**PROJECT NAME:** REPLACEMENT OF 3<sup>RD</sup> FLOOR CONCRETE SLAB AT  
GENESIS TOWERS  
**SPECIFICATION No.:** 2026-100-007  
**ADDENDUM No.:** 1  
**DATE ISSUED:** FRIDAY, MARCH 20, 2026

#### **NOTICE OF CLARIFICATIONS, CHANGES, ADDITIONS, OR REVISIONS**

QUESTIONS FROM BIDDERS, WITH RESPONSES FROM GARY HOUSING AUTHORITY AND ITS CONTRACTORS:

**NEW CONCRETE SLAB**  
SHEET NO. **S-200**

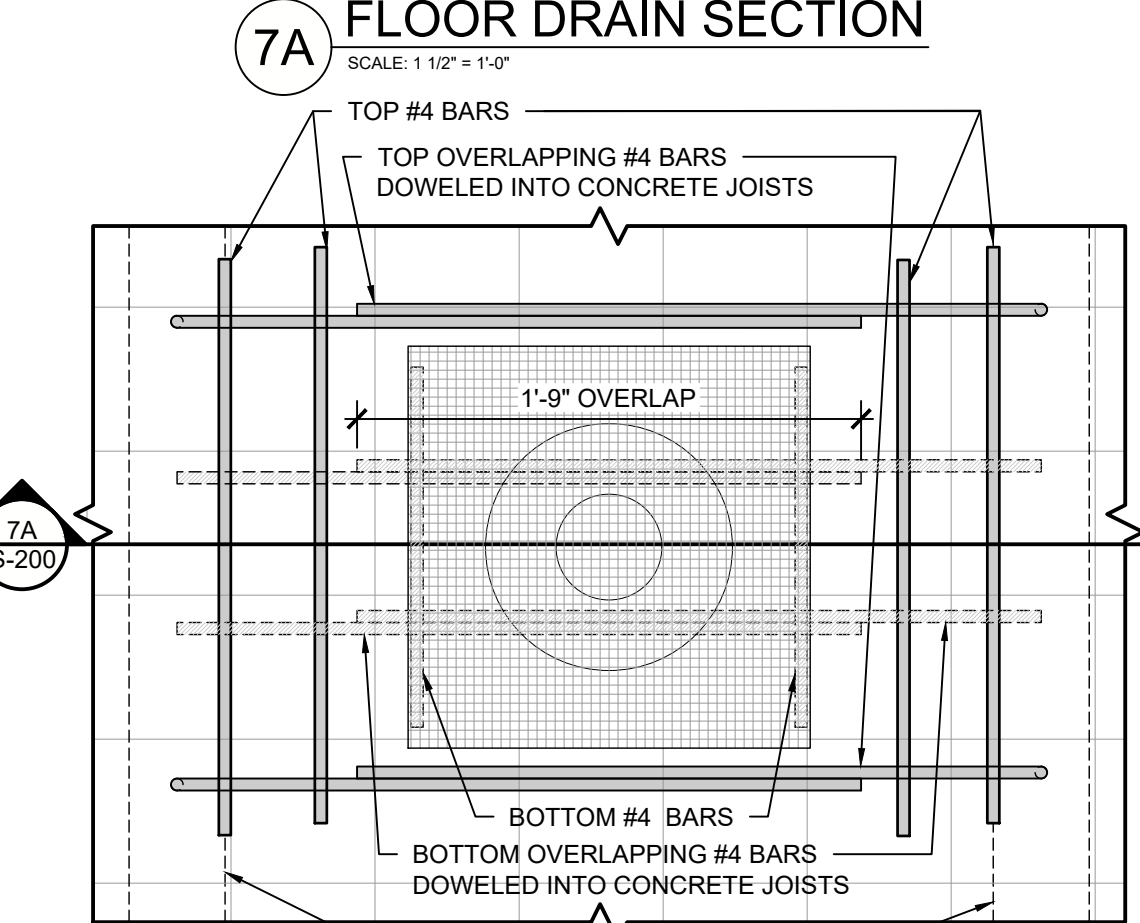
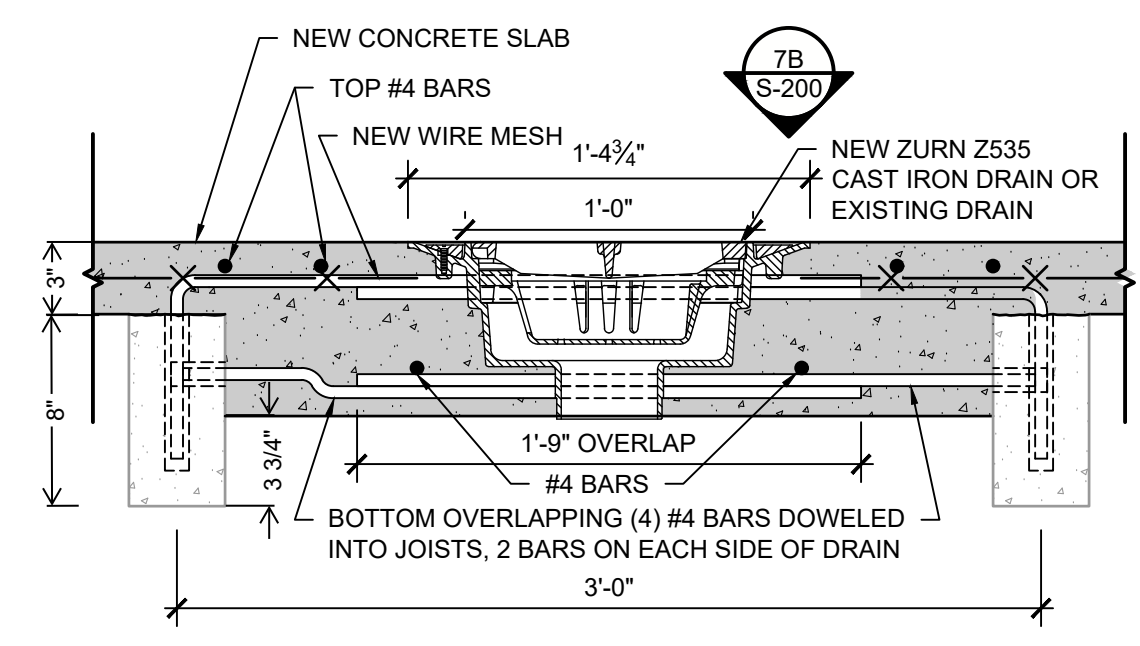
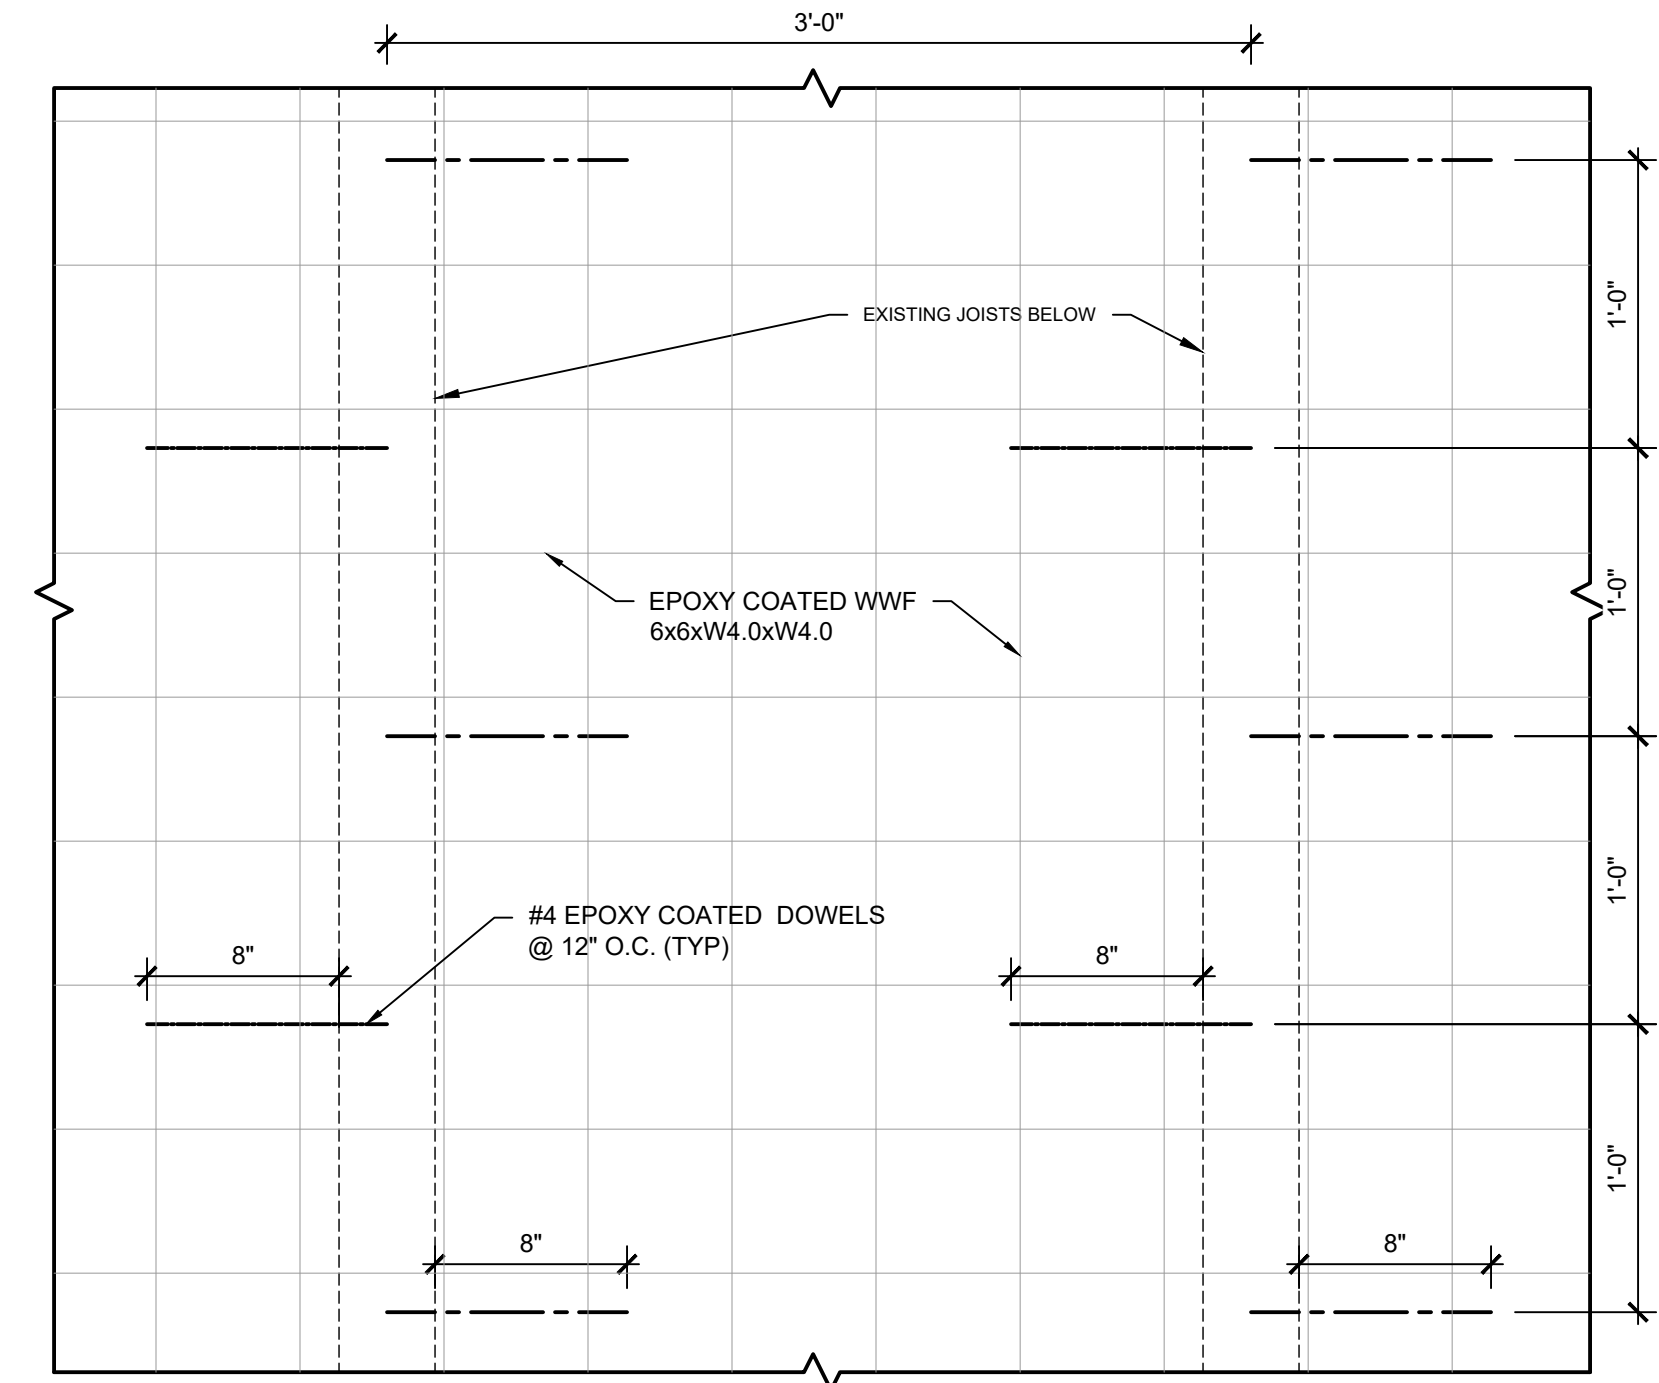
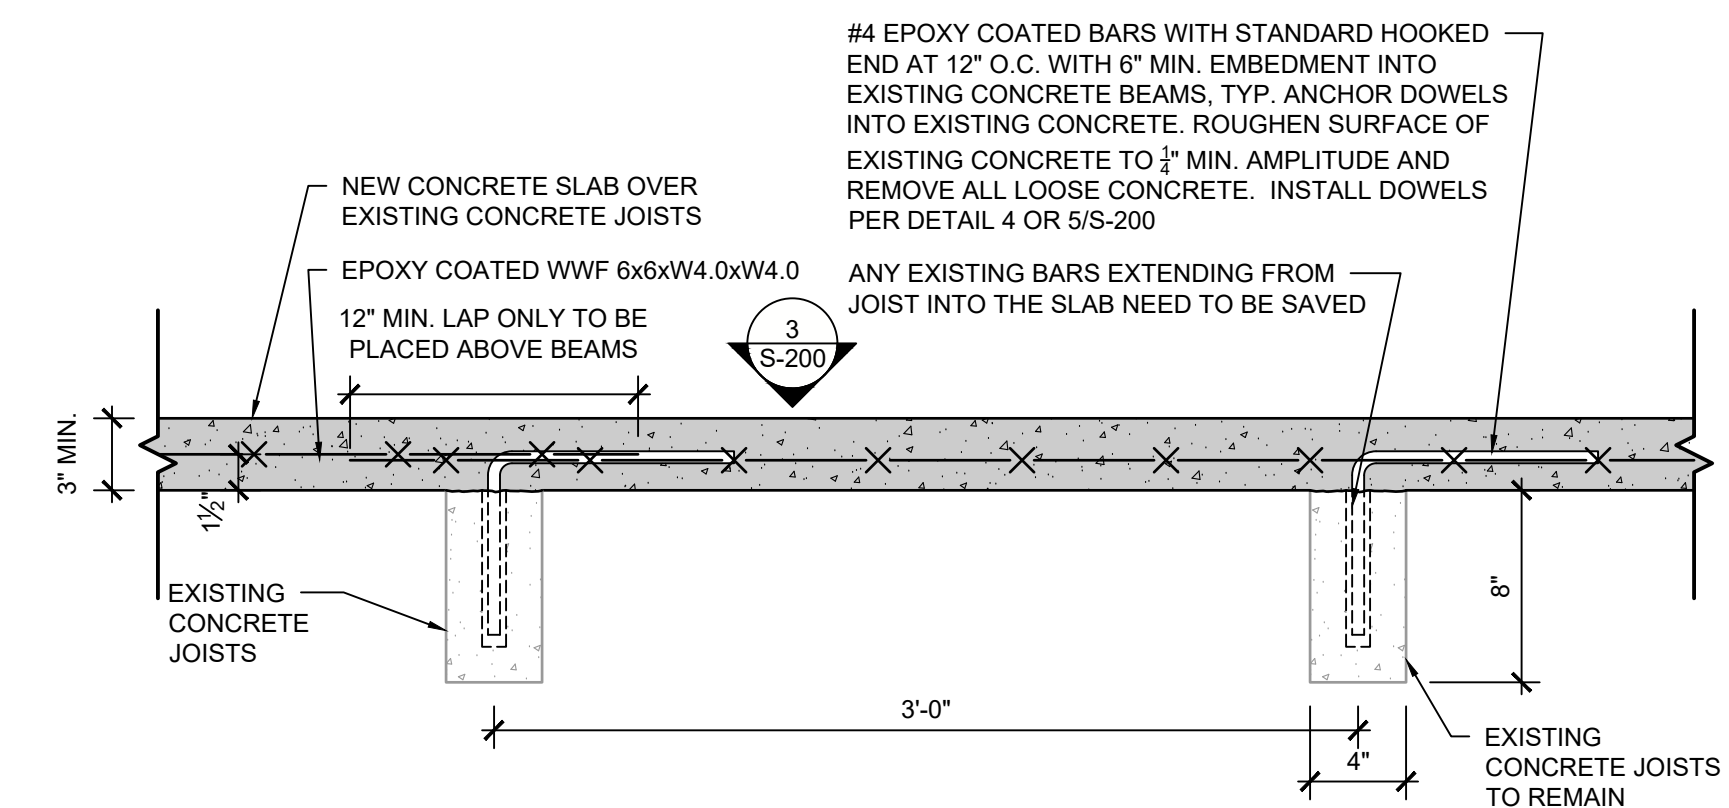
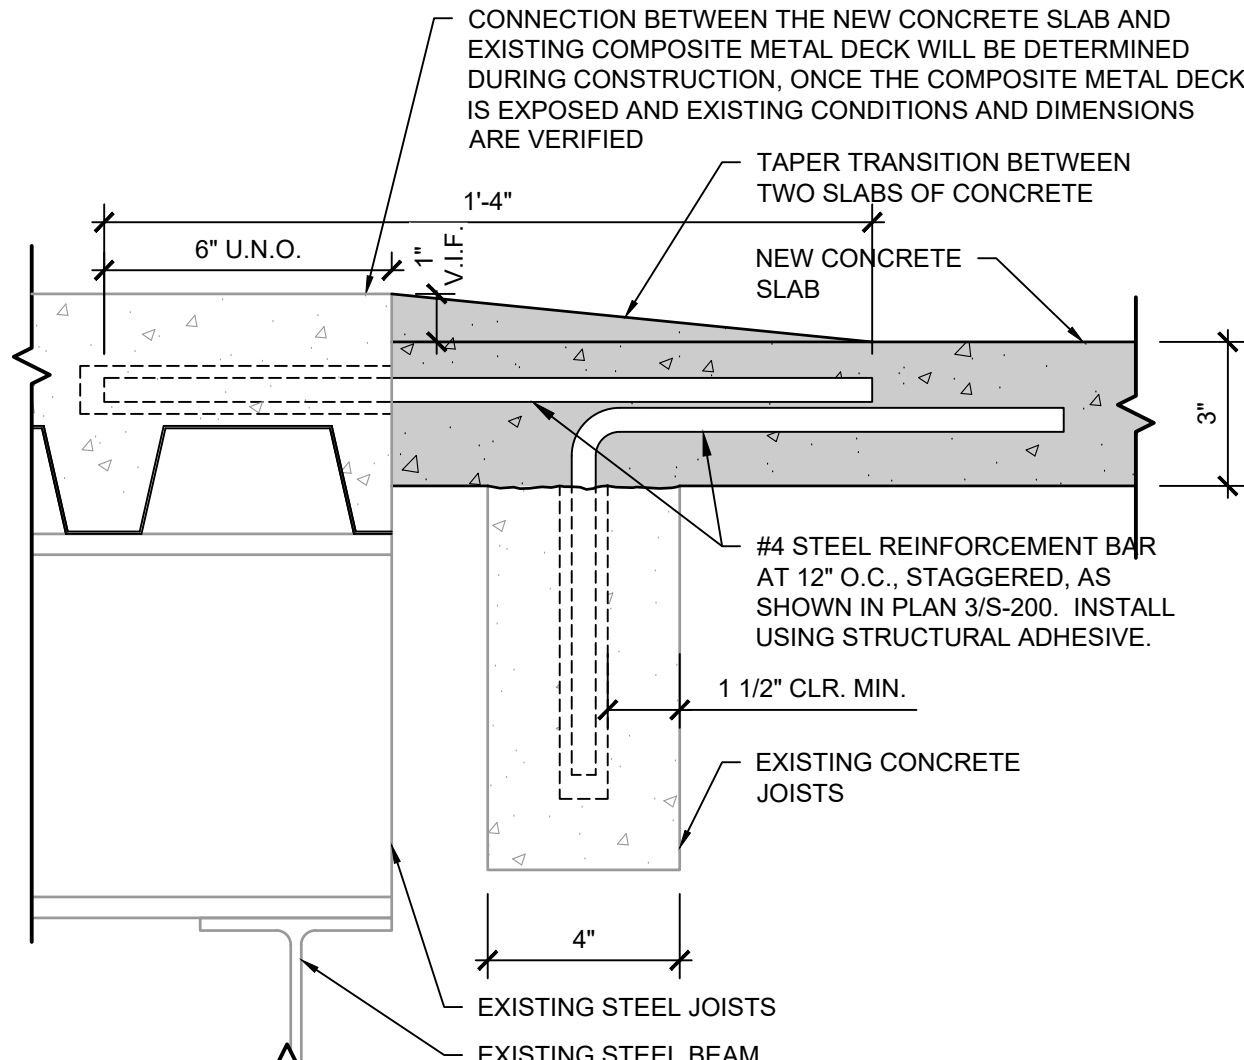
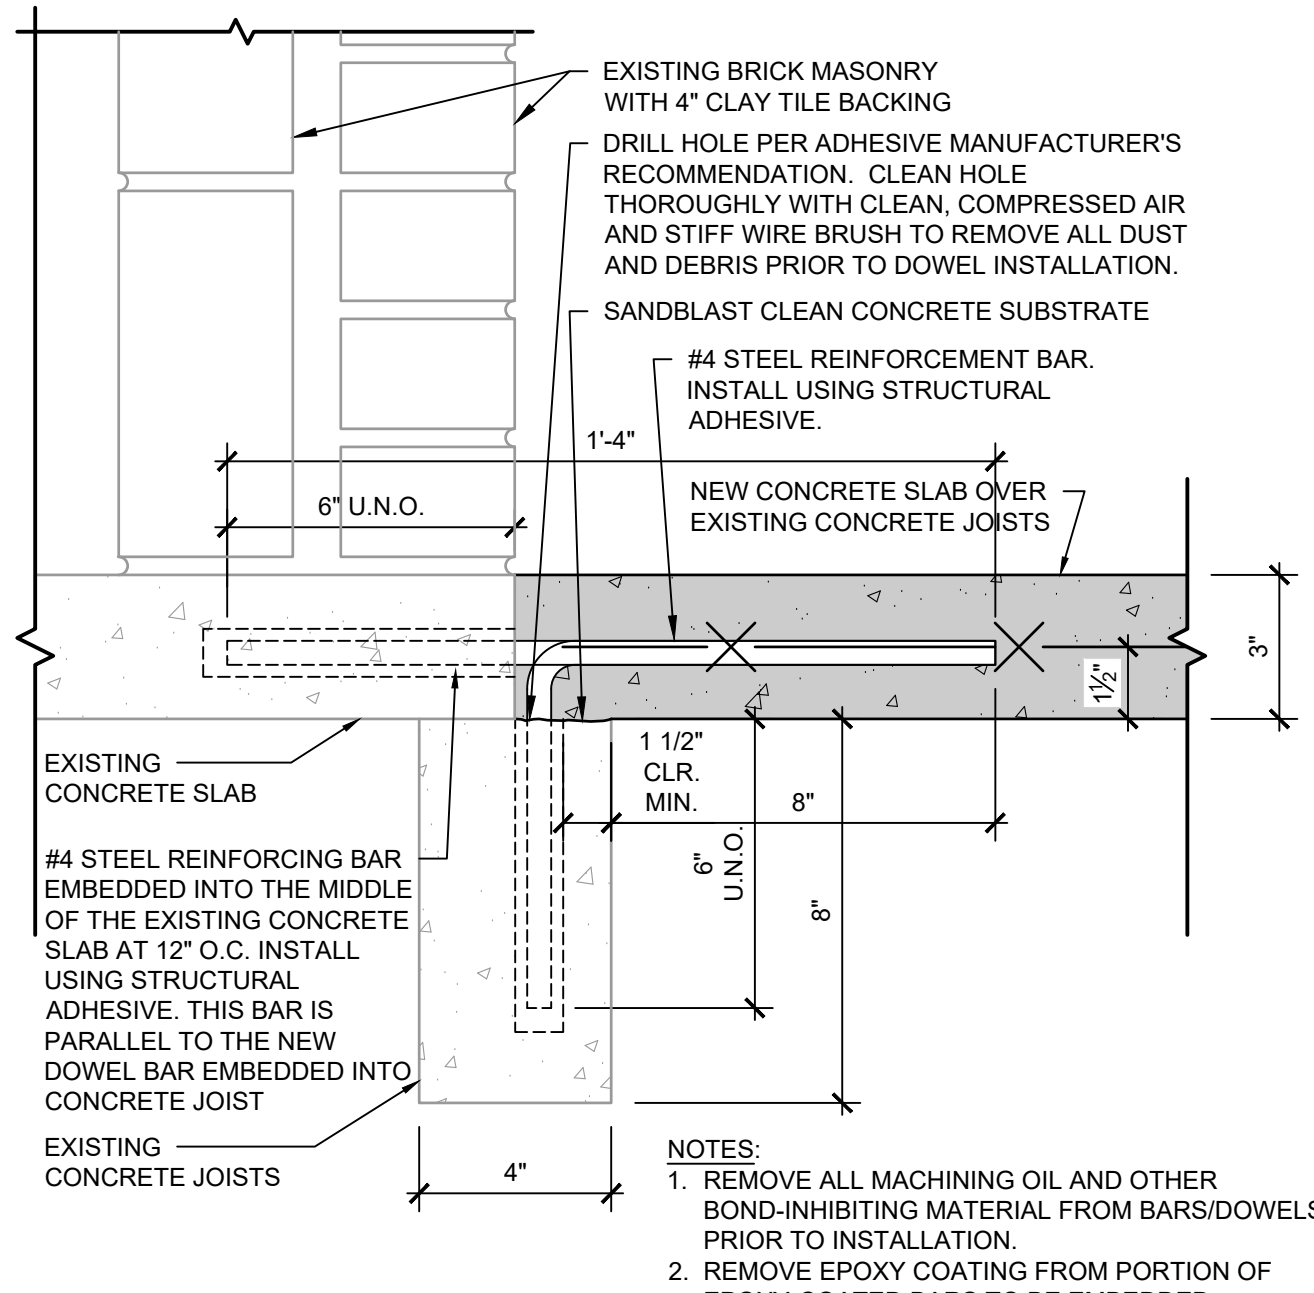
**Question 1:** On sheet S-200 detail #5 drawing shows #4 rebar installed into existing slab, does new slab pour to existing, or their expansion material between the two and then sealed?

The new concrete slab will be poured directly against the existing slab, with no expansion material between them.

**Question 2:** Plan S-200 indicates that there are nine (9) existing roof drains. After today's walk through, there only appears to be four (4). Are we just replacing the four (4) or are we replacing them all? The only four (4) that are existing are on the corners. All three (3) in the middle between column lines 4 & 5 as well as the middle two (2) between C & D are missing.

During removal of the existing waterproofing membrane at the top of the concrete slab as part of the restoration of the 3<sup>rd</sup> floor deck, it was discovered that four (4) drains present in the corners were present

and operable but installed too high to allow water to drain adequately. These 4 drains will need to be reset lower to accommodate proper drainage prior to placement of the new concrete slab. At two other locations, drains had been removed during previous repairs, and their openings were covered with plywood and steel plate. A total of six (6) new drains will need to be installed to accommodate adequate drainage from the new slab. Locations of the new drains will need to be field verified based on slopes of the new concrete slab that could realistically be achieved to provide proper drainage. We project a total of 6 new drains along with 4 existing (to be adjusted) for proper drainage. An elevation survey will need to be conducted during construction to determine and verify the achievable slopes, and based on that, identify the exact locations of the new drains. The attached revised Drawing S-200 show a total of nine (9) drains, and we have requested an additional as a floater (if necessary).
